Commonwealth Edison
One First National Plaza, Chicago, Illinois
Address Reply to: Post Office Box 767
Chicago, Illinois 60690

Subject: Dresden Station Unit 2
SEP Topic VI-7.C.1
Docket No. 50-237

IPSAR Section 4.21.1
Breaker Adequacy

125V DC SYSTEM SINGLE LINE

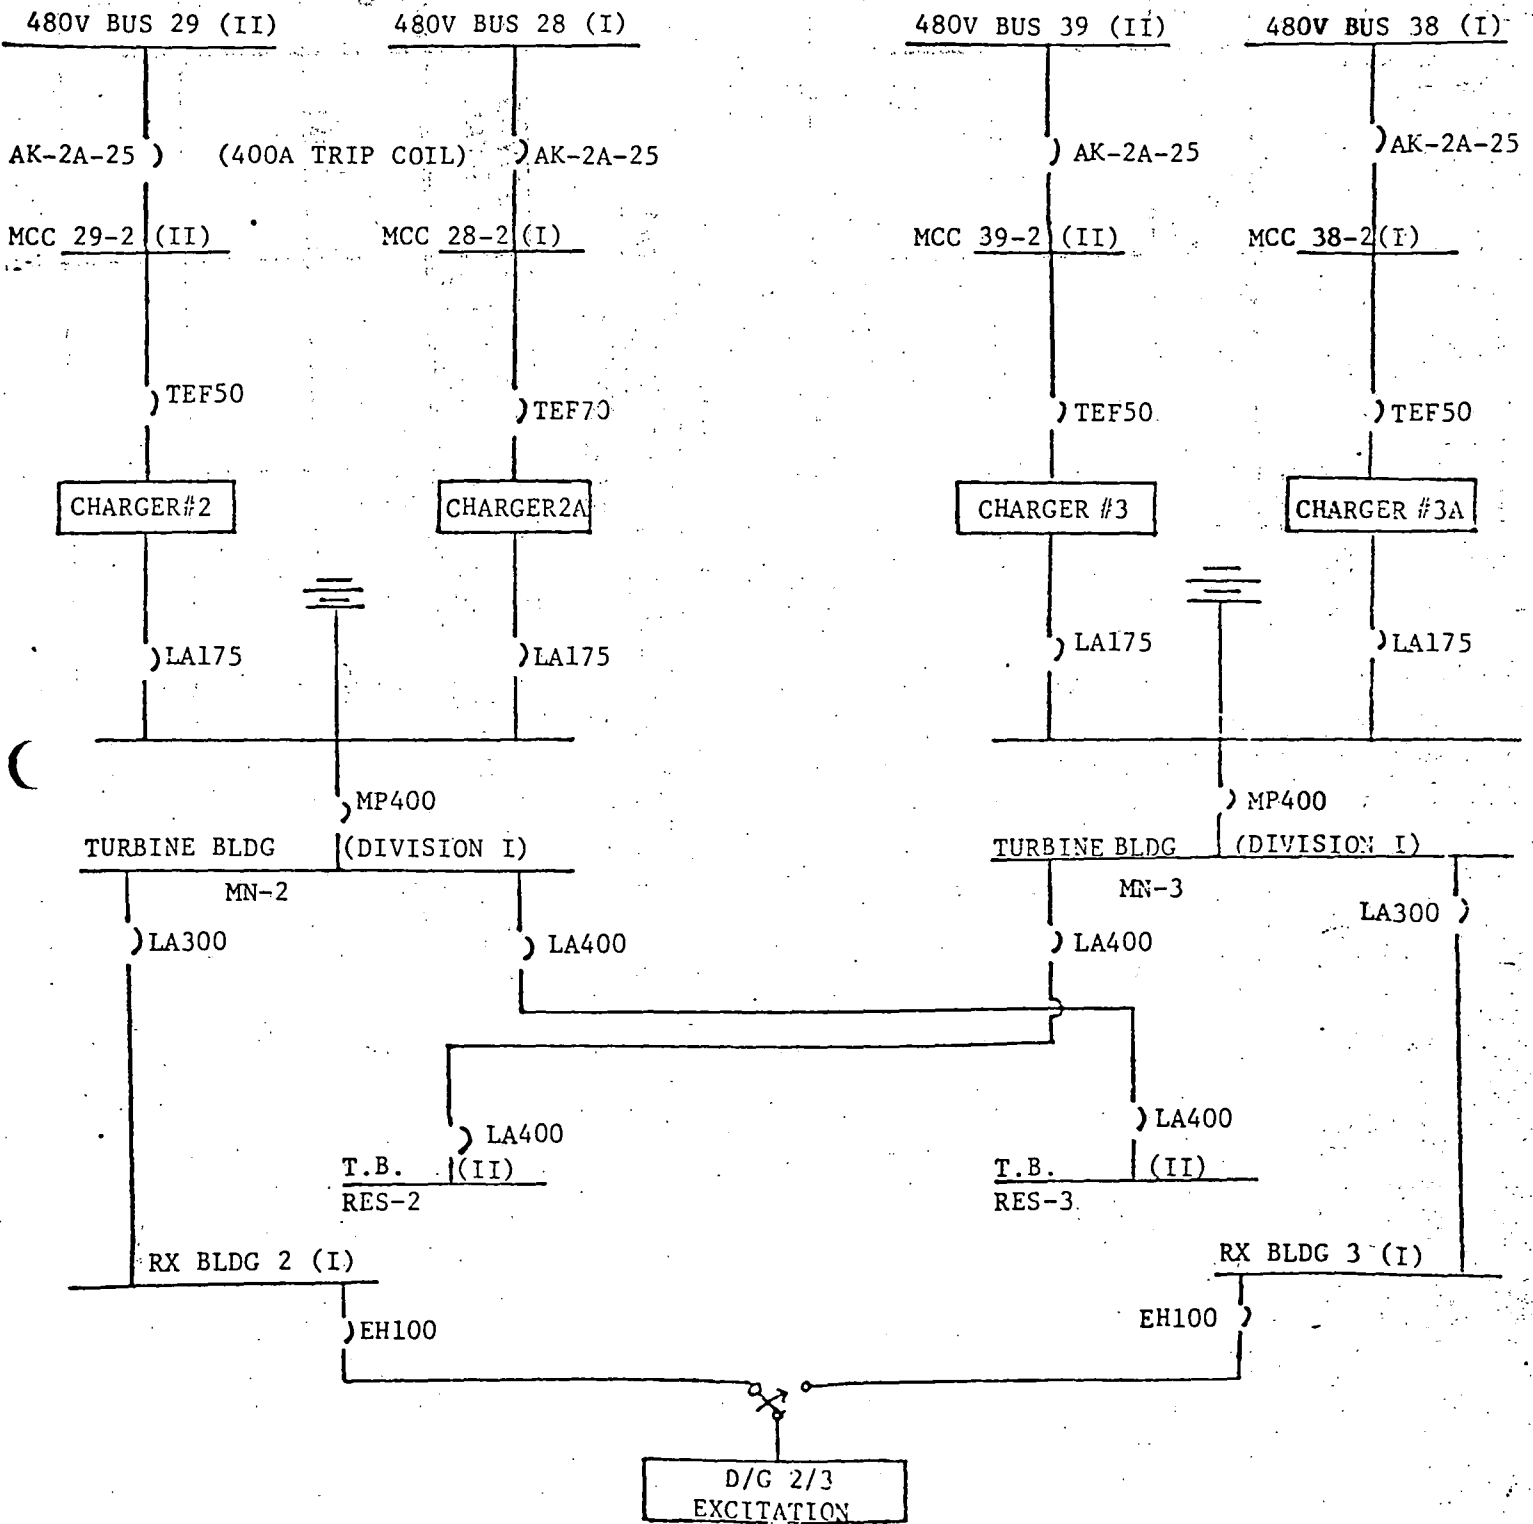
Division I motor control centers (MCCs) and Division II MCCs can be subjected to common faults and transients that may occur on the dc system if their respective battery charger output breakers are both closed. Individual manually operated circuit breakers connect the outputs of each of the chargers to the single battery and dc loads. The manual aspect of the design meets review guidelines defined in position D.4.d of Regulatory Guide 1.6. However, the two ac breakers and two dc breakers per charger plus the isolation characteristics of each charger provide isolation and separation of ac power sources. Thus, there is not direct connection of ac power systems. It is the staff's position that the licensee verify the adequacy of the protective relaying so that operator error will not result in a loss of redundant ac sources.

The design of the 125-V dc system provides for the automatic transfer of the control and instrument power for the diesel generator (DG 2/3) from the Unit 2, Division I, 125-V dc distribution panel to the Unit 3, Division I, 125-V dc distribution panel. The Unit 3 battery/battery-charger combination is the power source for both Unit 2, Division II, and Unit 3, Division I. Therefore, the diesel generator control and instrument loads are automatically transferred between redundant divisions. This is a deviation from current review criteria.

As shown in Exhibit 1, each unit's 125V battery bus has two chargers connected to it. Only one of the chargers is required at a time. Therefore, only one of the two charger breakers needs to be closed.

As shown in Exhibit 1, the diesel generator 2/3 excitation cabinet can be fed from either the Unit 2 reactor building distribution panel or from the Unit 3 reactor building panel. The Unit 2 reactor panel is part of Division I of Unit 2. The dc source for the Unit 3 reactor panel also feeds Division II of Unit 2. Therefore, whenever excitation cabinet load is automatically transferred from the Unit 2 reactor panel to the Unit 3 panel, this load is connected to a power supply which is feeding Division II of Unit 2. The NRC has questioned whether a fault downstream of the diesel generator 2/3 excitation cabinet transfer switch could cause the loss of redundant dc division of Unit 2.

250V DC SYSTEM SINGLE LINE

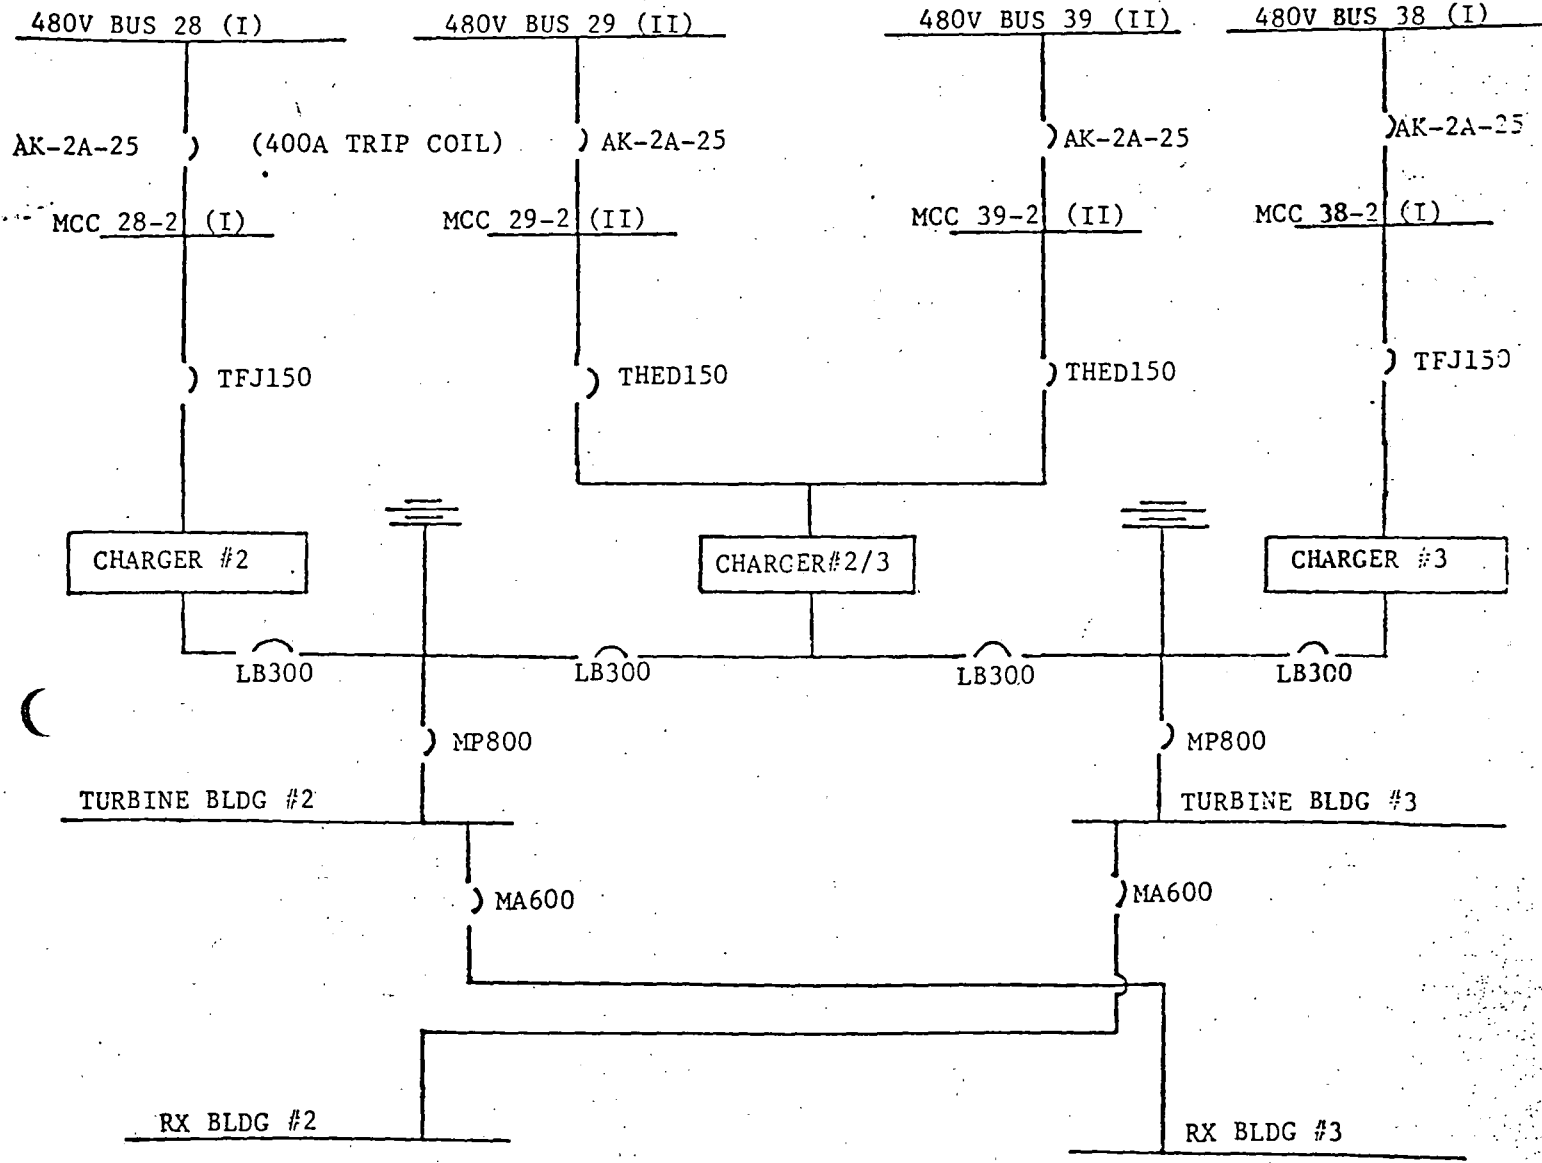
The standby 250-V battery charger (a Division I system) is supplied power from either the Unit 3 or Unit 2, Division II power source through a key-interlock switch. When power is supplied from Division II of Unit 3 to the Unit 2 battery, there is sharing between Units 2 and 3. This sharing is covered by SEP Topic VI-10.B. When power is supplied from Division II of Unit 2 to the Unit 2 battery, there is an interconnection between redundant divisions. It is the staff's position that the licensee verify the adequacy of the protective relaying so that a fault in one dc system would not be transferred to the other dc system.

As shown in Exhibit 2, the 250V standby charger 2/3 can be fed from either a Unit 2, Division II or a Unit 3, Division II ac MCC. Battery charger 2 is fed from Division I of Unit 2.

When the swing charger is used to feed the Unit 2 turbine building 250V dc MCC and is itself fed from the Unit 2, Division II ac MCC, and the breaker for battery charger 2 is closed, then both redundant ac divisions would be connected to the same 250V dc MCC. The NRC has questioned whether a fault on the dc MCC under this condition could cause a loss of both redundant ac divisions of Unit 2.

BREAKER COORDINATION FOR
DIESEL GENERATOR 2/3
EXCITATION CABINET FEED

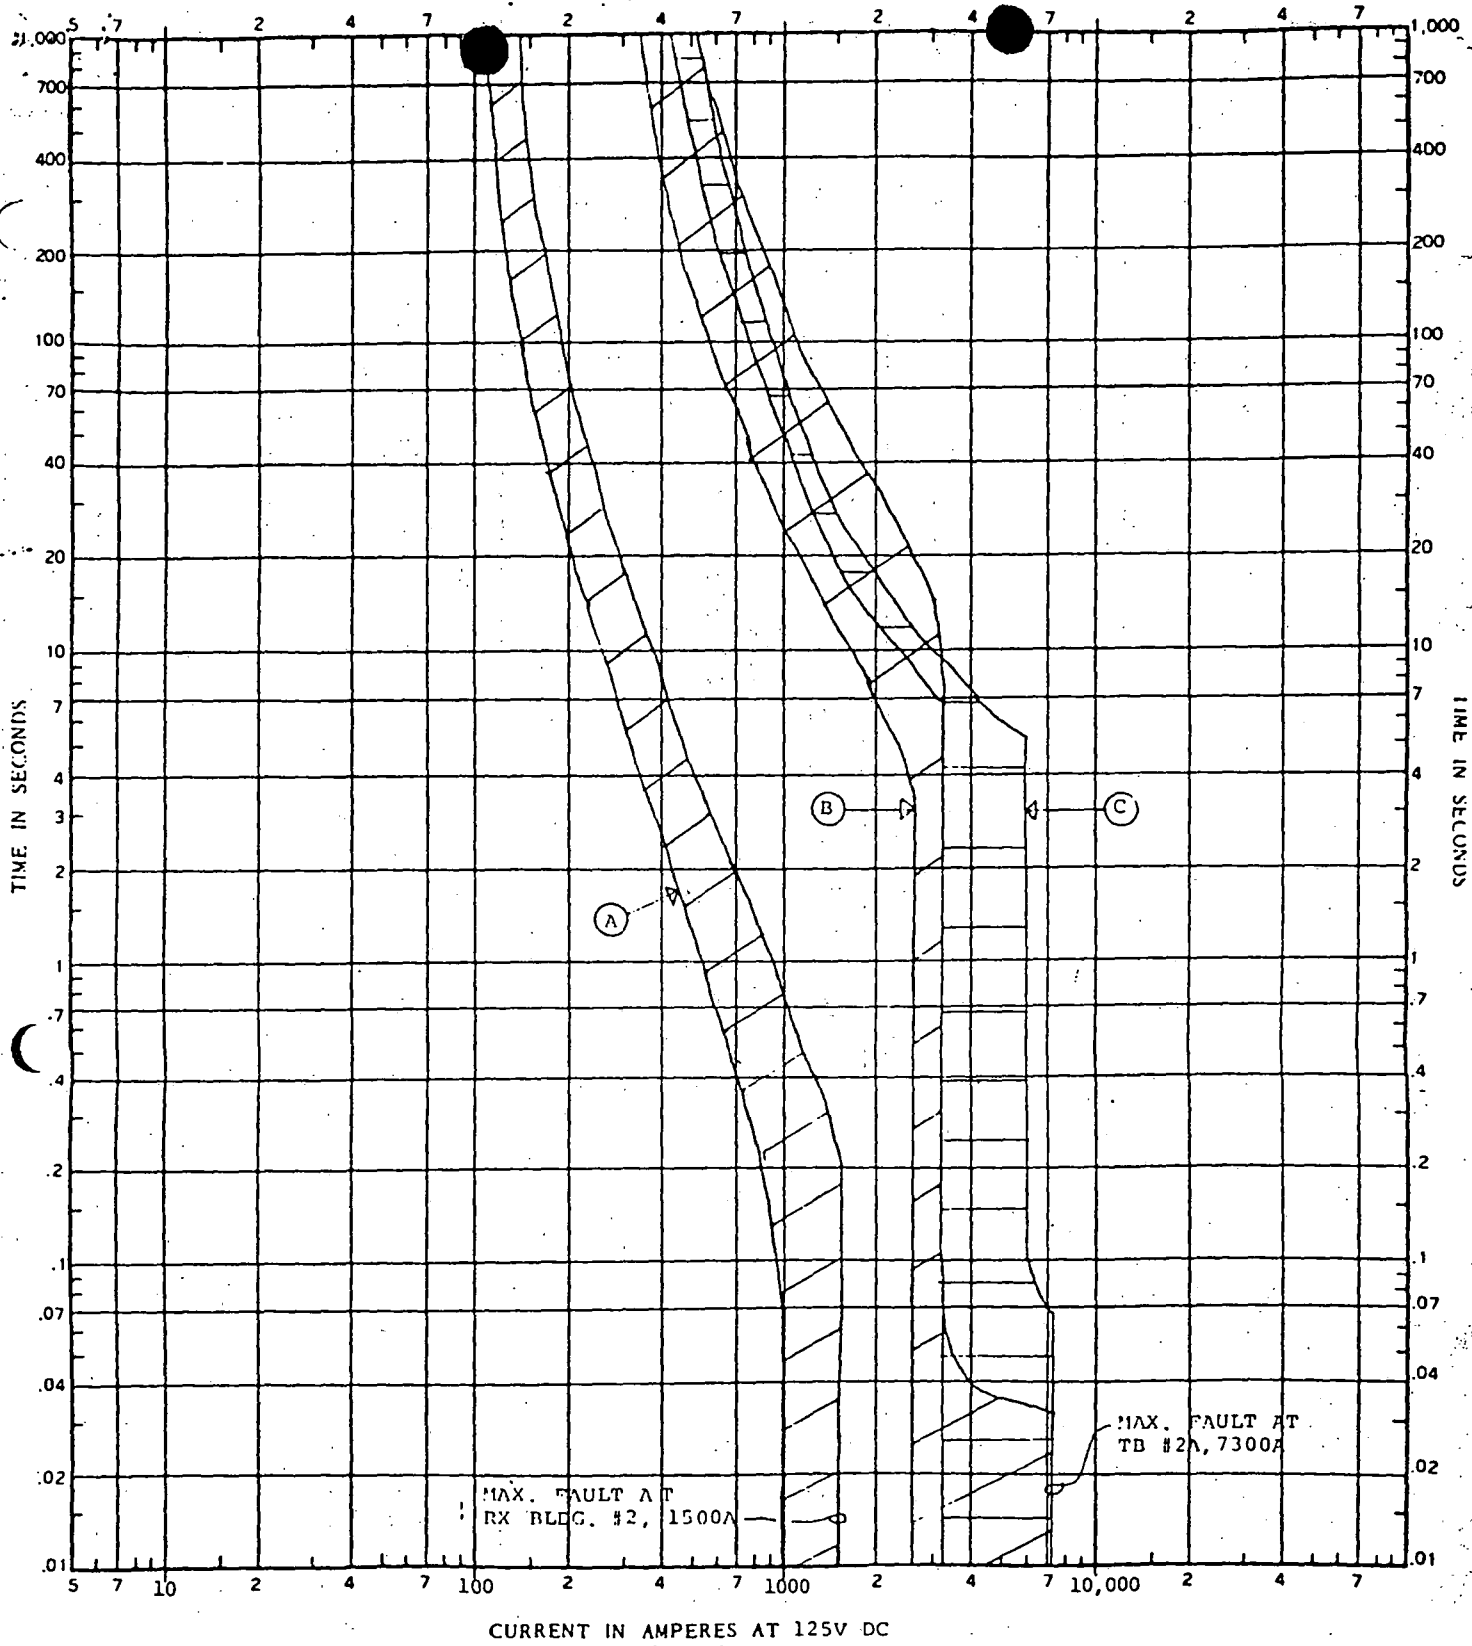
It is the staff's position that the licensee verify the adequacy of the protective relaying so that a fault in the DG 2/3 control system will not result in a loss of redundant dc sources.

As indicated by the breaker coordination curves shown in Exhibits 4 and 5, a fault on the feed to the diesel generator 2/3 excitation cabinet will not cause an instantaneous trip of the MP400 main breaker feeding the turbine building Division I bus. The maximum fault level at the reactor building Unit 2 panel is below 1500A, whereas the minimum instantaneous pickup of the MP400 is about 3200A. The cable resistance used to calculate the maximum fault current are indicated in Exhibit 6.

If the EH100 breaker fails to open, the load will be transferred by the undervoltage sensed to the other source after about 1 second. Therefore, the long time portion of the MP400 breaker will not operate. A single failure will, therefore, not cause the loss of redundant dc divisions.
